Subject: Notification of Planned Change to the Permitted Facility Underground Hazardous Waste Disposal Unit Panel 4

Notification of Planned Change to the Permitted Facility

Underground Hazardous Waste Disposal Unit Panel 4

ATTACHMENT A
Typical Filtration Unit

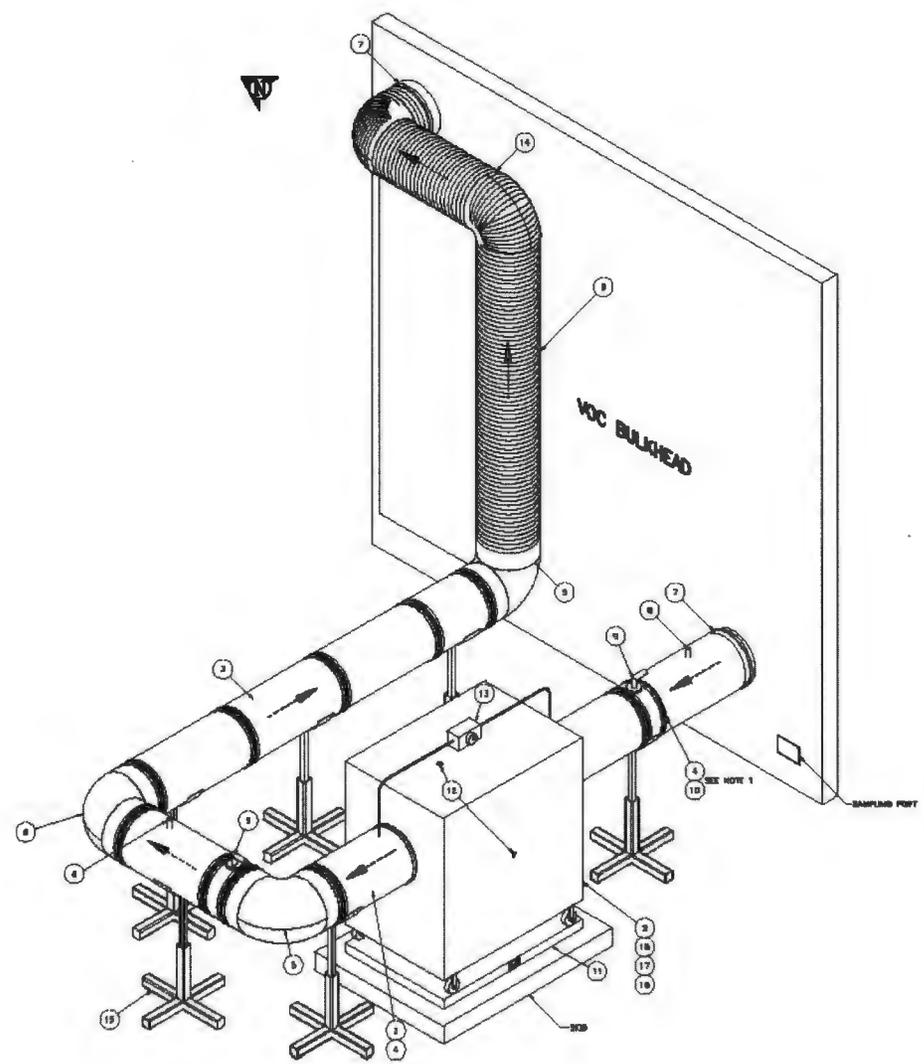
1. Installation of additional bulkhead to be identified as the Volatile Organic Compound (VOC) bulkhead adjacent to the existing bulkhead in S-3650.
2. Installation of a filtration unit (e.g., granular activated carbon, zeolite, or similar filtration media) in S-3650 to reduce carbon tetrachloride emissions. This unit is tentatively scheduled for installation in the October 2010 timeframe.
3. Use of zeolite or similar filtration media in the exhaust side filtration unit (in S-3310) described in the Notification submitted to your office on January 27, 2010.

The filtration system is being used to reduce carbon tetrachloride emissions.

The filtration unit is a commercially available system similar to that shown in Attachment A and the filter will consist of removable filtration media.
